Clattering noise when raising/lowering window using the front door window lifter

Topic number	LI72.10-P-073487
Version	1
Function group	72.10 - Front door
Date	8/17/21
Validity	MODEL 223 up to VIN ending in A023009.
Reason for change

File	Description
Bild 1.JPG

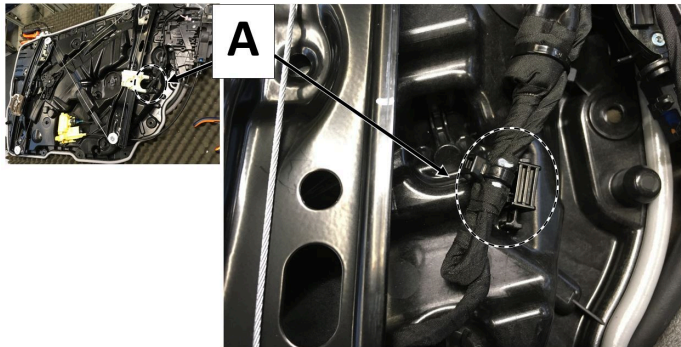
Clattering noise when raising/lowering window using the front door window lifter; occurs when side window is at mid-way point of its travel.

When the side windows are being raised/lowered, the rear window lifter driver may come into contact with the door module wiring harness.

1. Remove door module for front door.
2. In area "A", see Picture1, release the existing cable strap, incl. wiring harness, from the securing strip on the door module. Remove cable strap from wiring harness. Fasten new cable strap (see parts list) to wiring harness and attach to securing strip on door module. Pay particular attention to the position of the wiring harness on securing strip, see Picture 1. After fastening wiring harness, cut off excess length of cable strap.
3. In area "B", fasten wiring harness to tab on door module with a cable tie, see Picture 2. After fastening wiring harness, cut off excess length of cable strap.
4. Install door module.
